EC18-004

ITB18-009

February 27, 2018

2018 QX60; MIL ON WITH DTC P34A5 AND/OR P34A9 STORED

Electric Intake Valve Timing Control Module Location

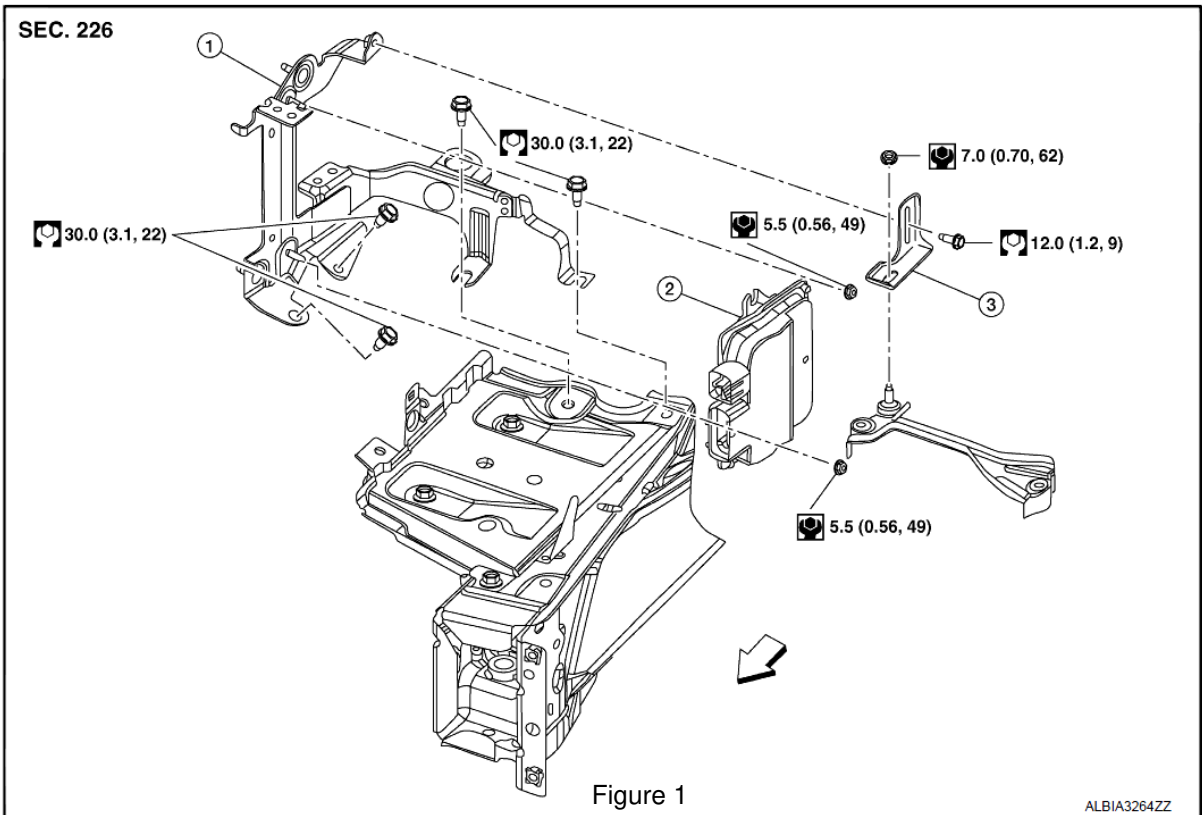
Replace the electric intake valve timing control module (see Figure 1 on Page 2).

- Electric intake valve timing control module is listed in the Parts Information of this bulletin.
- Refer to the Electronic Service Manual (ESM), section ENGINE > ENGINE CONTROL SYSTEM, for replacement information.
- Make sure to perform Electric IVT Control Actuator Position Learning after replacement of the module.

Figure 2

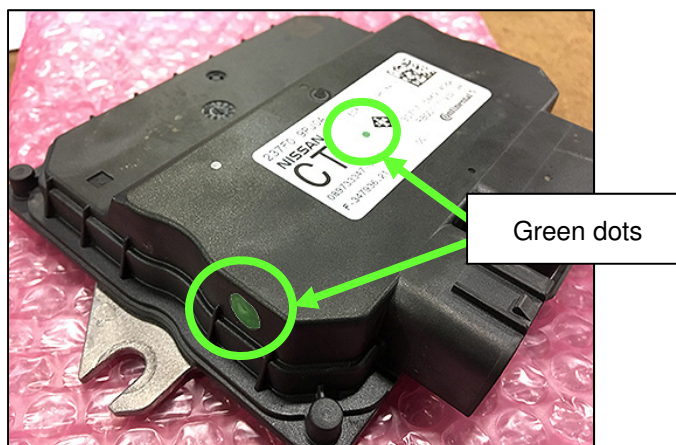
- (1) The new part must either have the green dots as shown in Figure 2 or an “AB” with additional QR on the label as shown in Figure 3, to indicate that it has the correct software version.
